# ***SERVICE PROCEDURE***

**G-09503  
JUNE 2009**

**SUBJECT: SAFETY RECALL (U.S.)  
CAB FEED BATTERY CABLE on certain 5500, 5600,  
and 5900 models built 1/7/07 thru 5/15/08 and  
equipped with feature code 008875 sealed battery  
cables.**

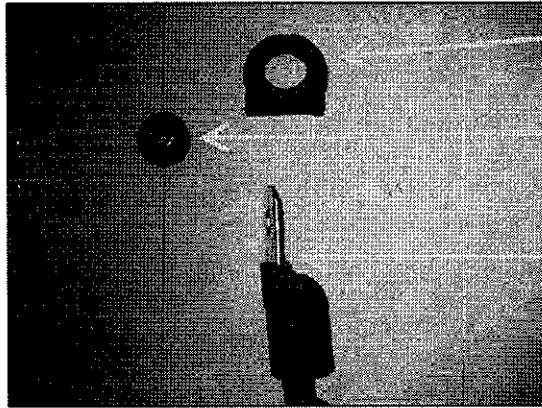
4. Cut and remove the end of the plastic cover of the sealed battery cable terminal. Enough of the cover should be removed to allow the block fuse to seat fully on the cable terminal. Retain the insulator nut. Discard the plastic end.

Discard Plastic End

Retain Insulator Nut

Cut back far enough for block fuse to fully seat on terminal.
